November 14, 2023

Subject: 1700 Asylum Avenue - IWW #1203
1800 Asylum Avenue –& IWW #1205

Todd Dumais
Town Planner and Designated Wetlands Agent

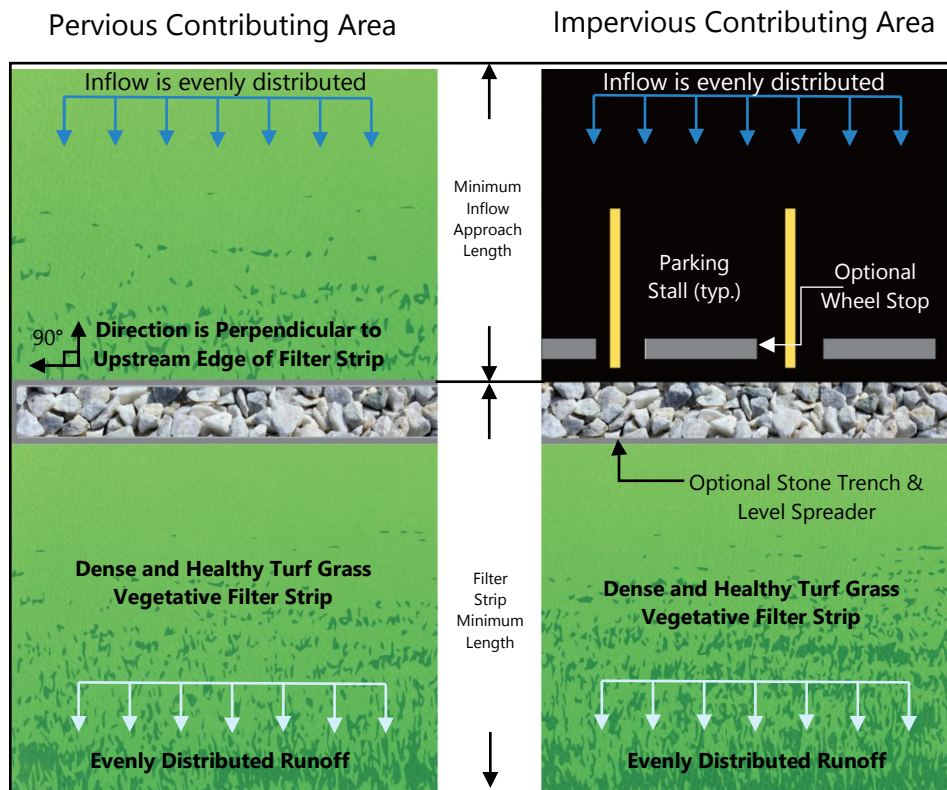
- 33. N/A.
- 34. **Comment addressed.**
- 35. N/A.
- 36. N/A.
- 37. **Comment remains not addressed. The ED notes that the proposed curb cuts and riprap energy dissipation pads collect minimal parking lot runoff (about**

0.13 ac.) for overland release to St. Joseph Brook, so it is unclear what the benefit is. Further, the discharge from the curb cuts will drain over the proposed concrete sidewalk directly east which is not ideal. A more ideal design would be to allow runoff from the parking lot along the length of St. Joseph Brook to sheet flow off the lot, unimpeded by curbing, filtered through a vegetated buffer before ultimately infiltrating into the ground or discharging to St. Joseph Brook. See attached plan markup and excerpt from *Connecticut Stormwater Quality Manual*.
